To: Jaxon Fagan, Public Service Company of Colorado/Xcel Energy
From: Audem Gonzales, Senior Planner
Date: May 24, 2019
Re: SPAA-001050-2019: Site Plan Amendment – Isabelle Substation FAN Project
SRU-001049-2019: Special Review Use – Isabelle Substation FAN Project
cc: Fred Starr, Director of Planning and Development

RE: Response to Staff Review comments on the Public Service Company of Colorado (PSCo) Special Review Use and Site Plan Minor Amendment Applications for the Isabelle Substation Field Area Network Project

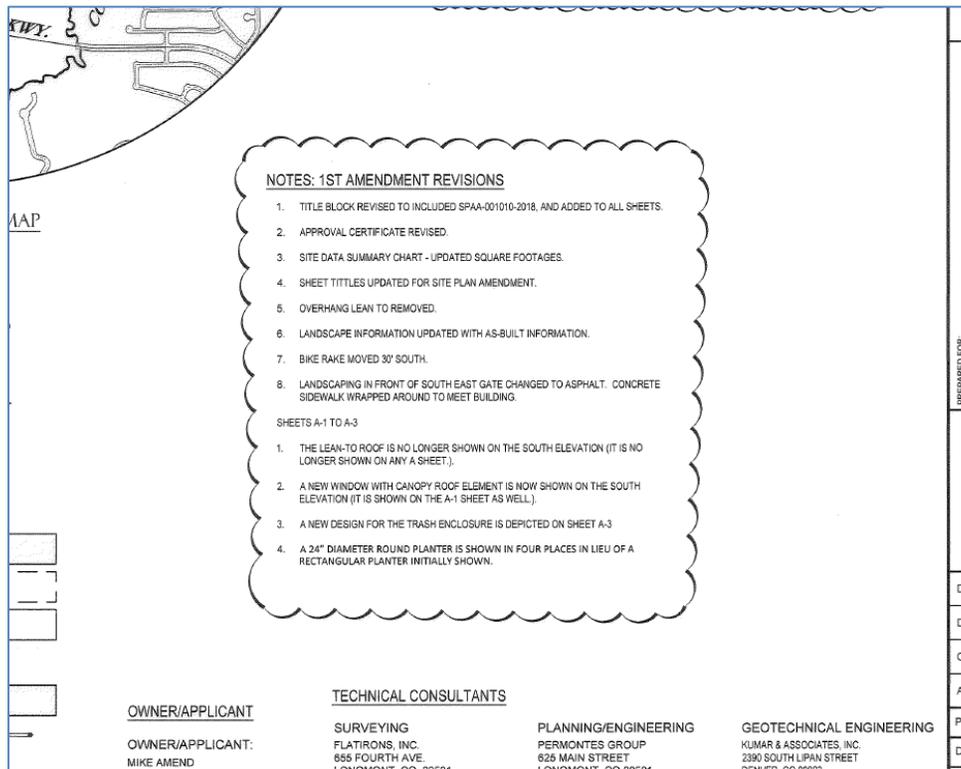
4. Create a note section title as “Site Plan Amendment No. 1” and list the proposed amendments. See example:

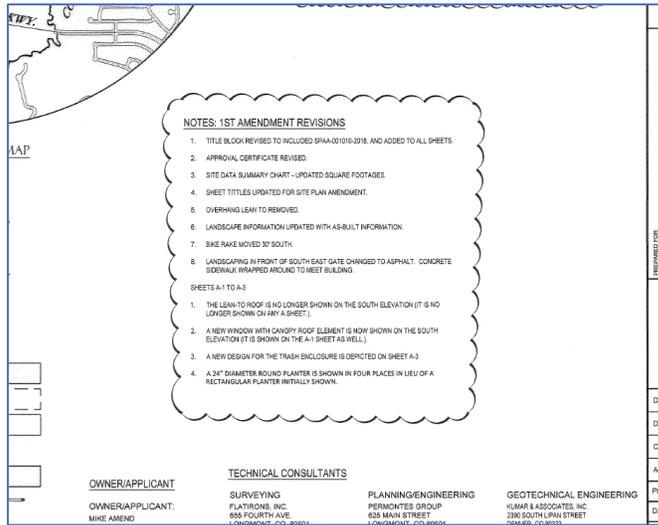
4. Create a note section title as “Site Plan Amendment No. 1” and list the proposed amendments. See example:

Response: “Site Plan Amendment No. 1” was added to Sheet 1 as referenced in the staff report.
